From: Mess, Camie
Sent: Monday, August 21, 2017 2:44 PM
To: Wolf, Fred
Subject: BAR Action - 230 West Main Street - Aug 15,2017

BAR 17-08-01
230 West Main Street
Tax Parcel 280001000
Taliaferro Junction LLC, Owner/ Fred Wolf, Applicant
Ice Park Arena Redevelopment

**CITY OF CHARLOTTESVILLE
BOARD OF ARCHITECTURAL REVIEW
STAFF REPORT
August 15, 2017**

**CHARLOTTESVILLE TECHNOLOGY
BOARD OF ARCHITECTURE REVIEW MASSING STUDY**

cut through Gallery

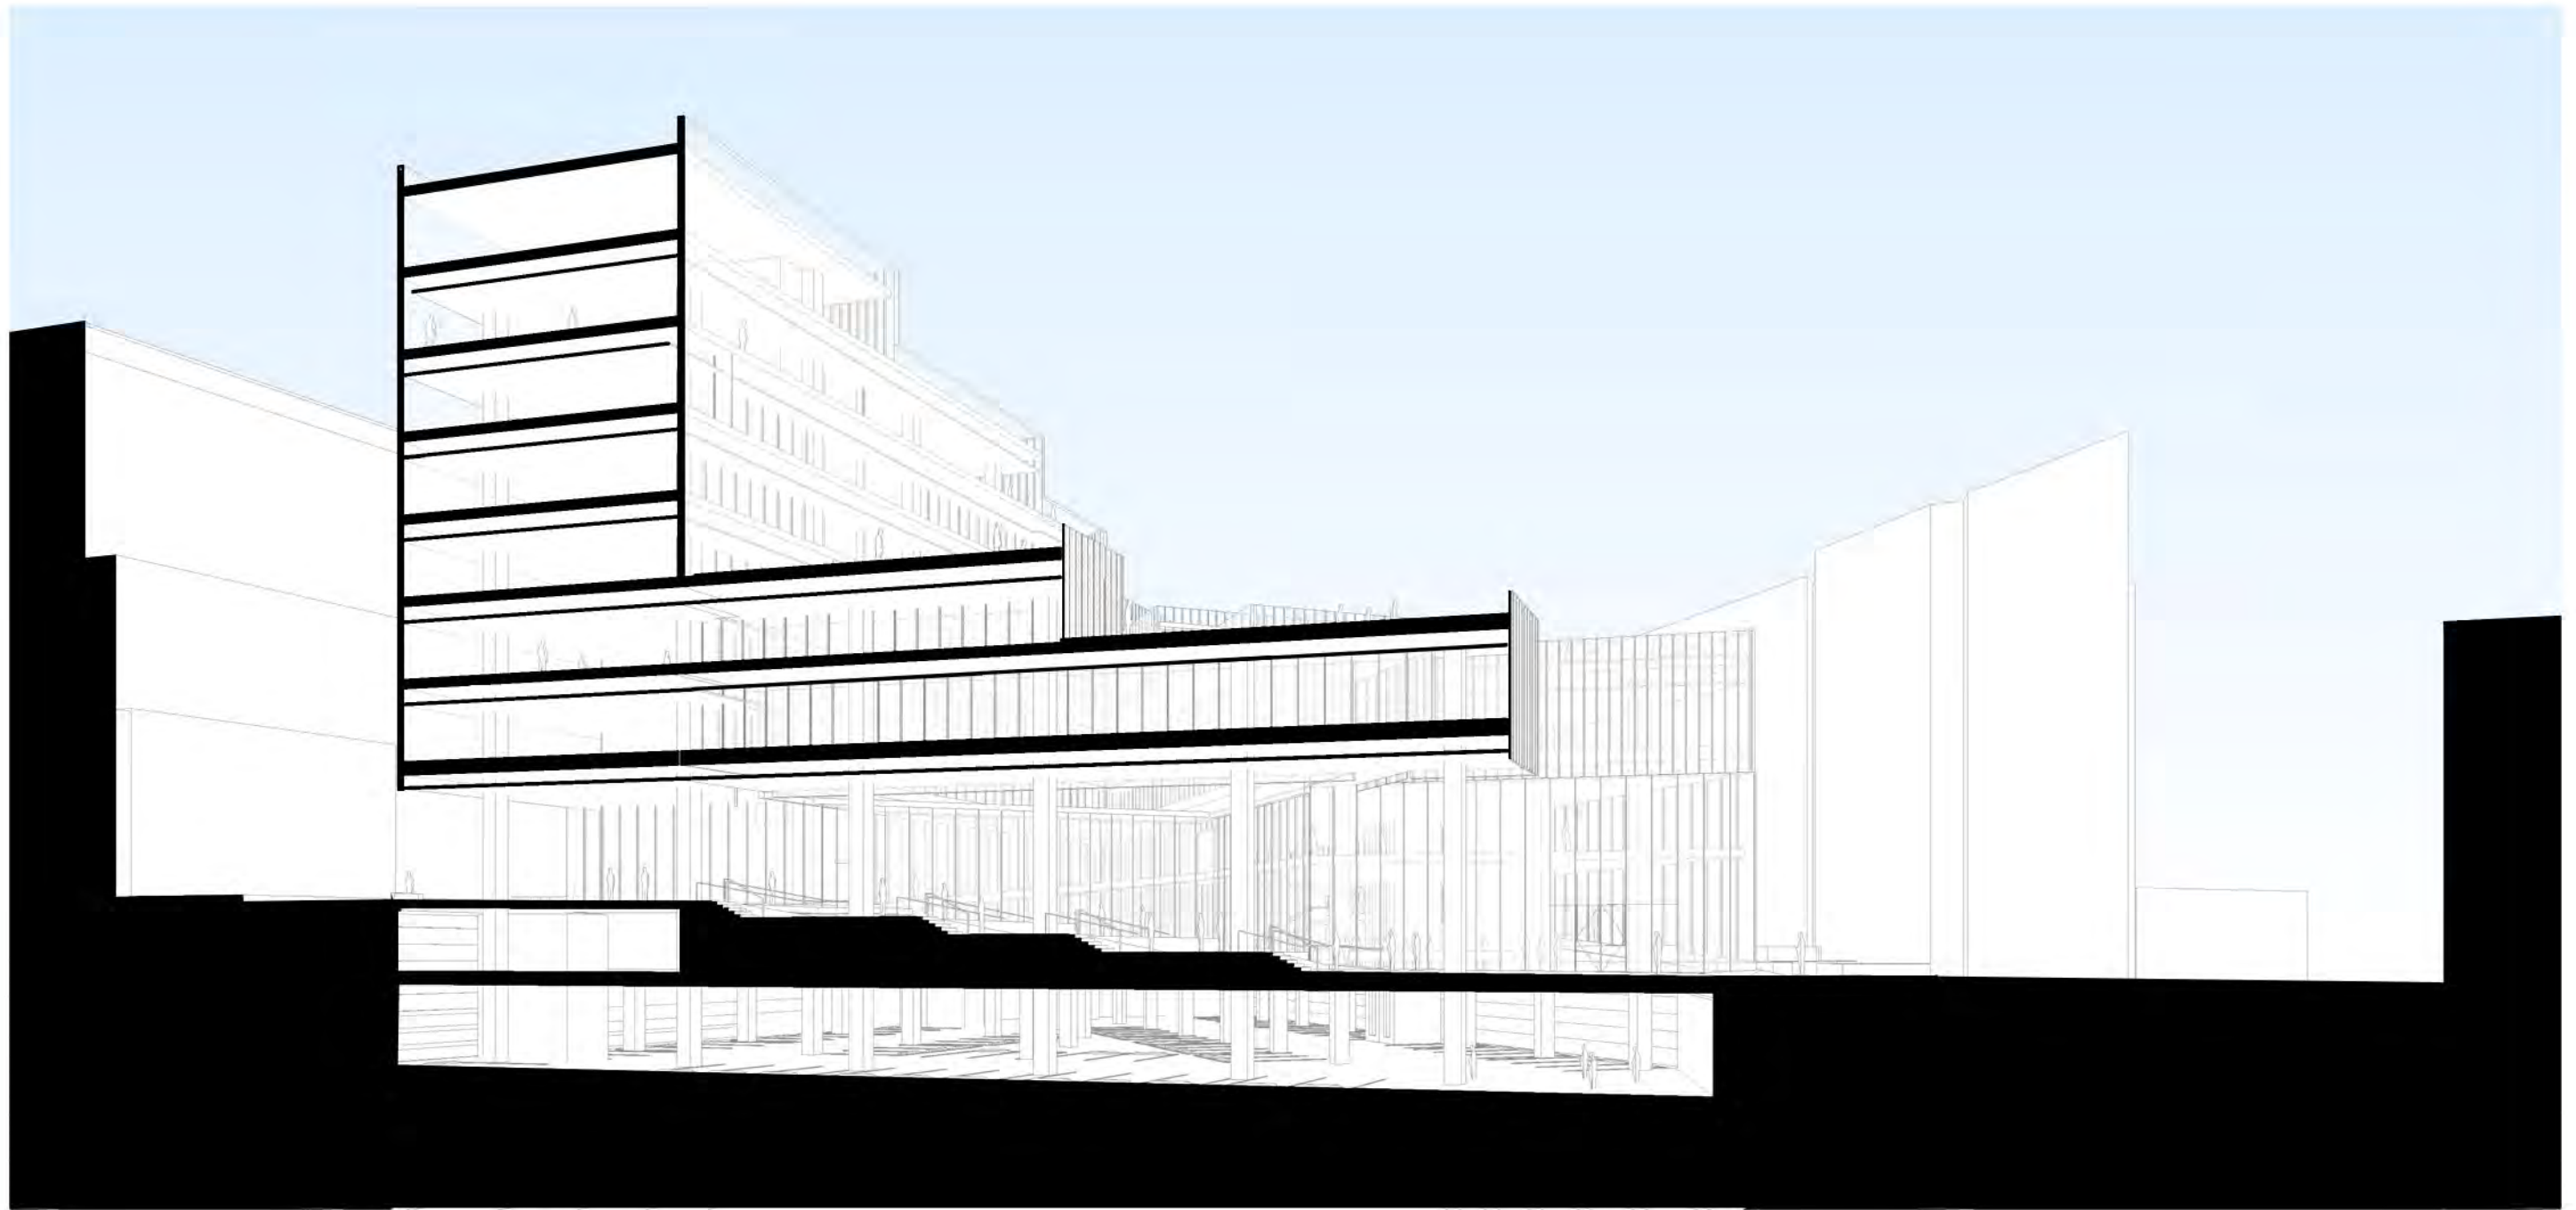
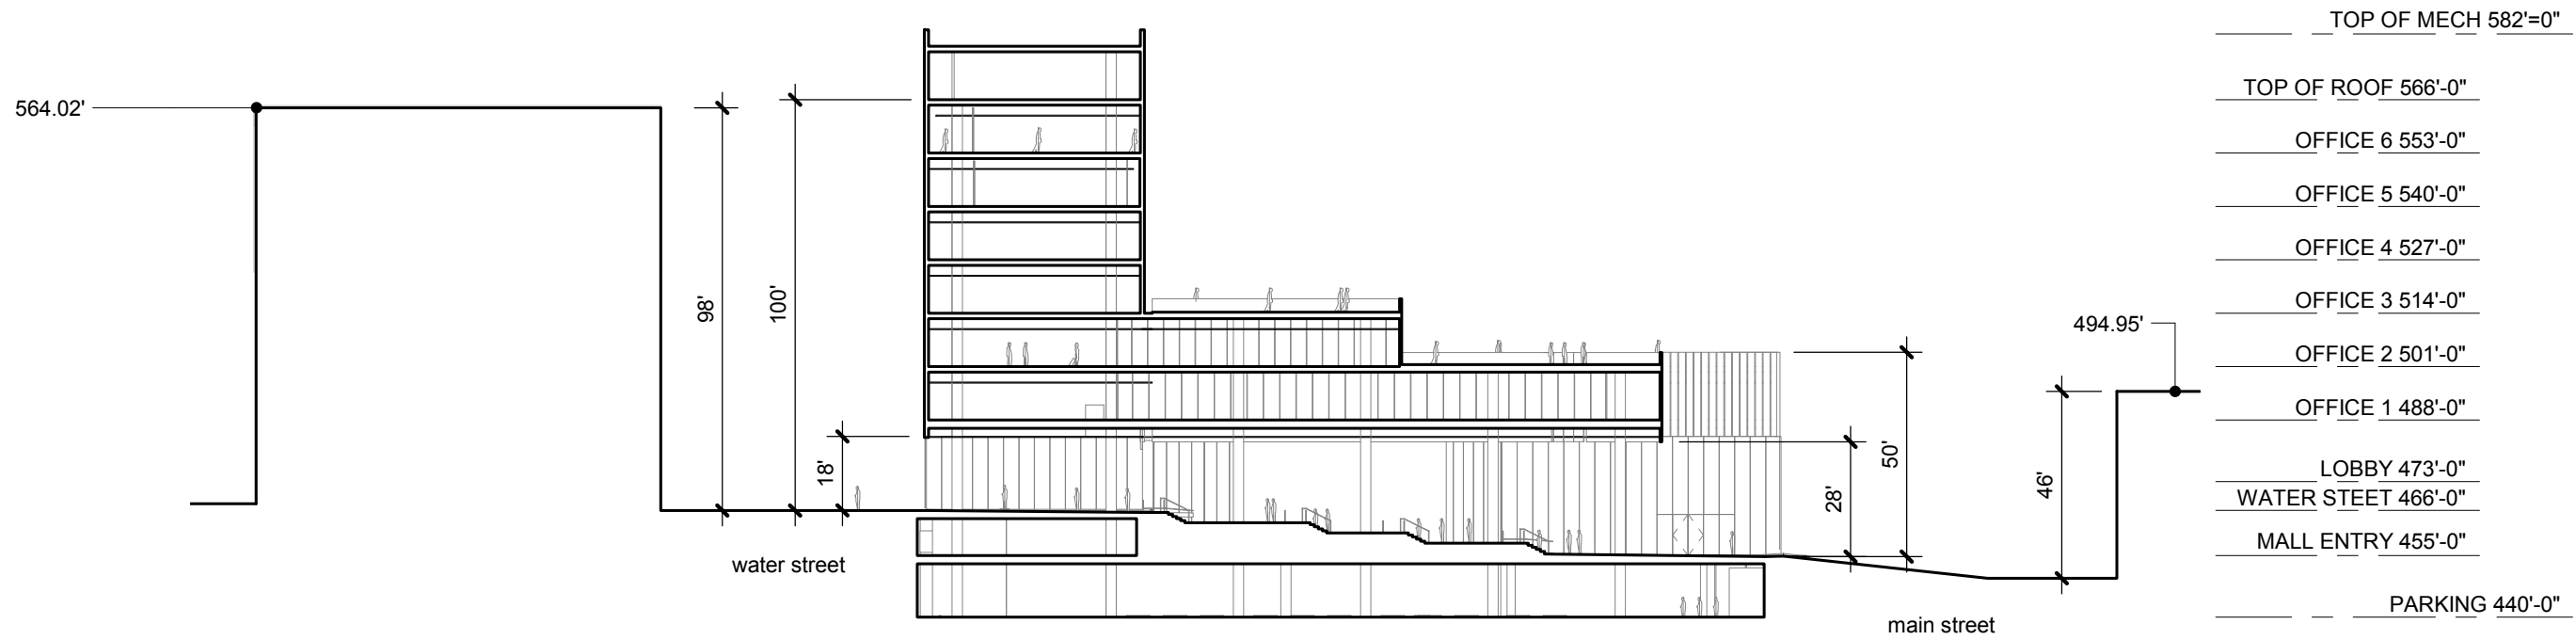
- **The idea of the arcade/gallery is the key part of this whole design concept, the BAR wants this to be welcoming to all pedestrians, not just the building users. Open it up more to the sky; celebrate it more on Water Street.**

0.5 LOBBY PLAN

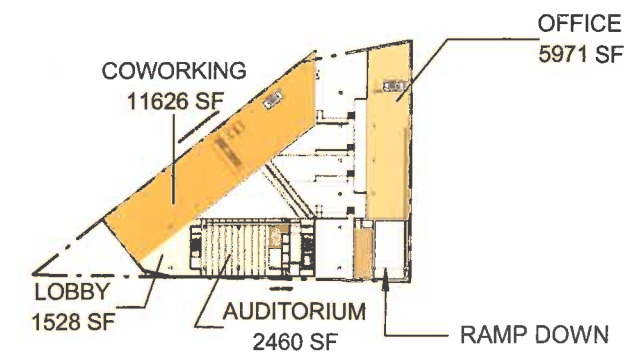
- **Go for higher in lobby area – it looks squished**
- **The massing is sensitive to the proportion of the mall, Water Street, and the walkway into the mall**
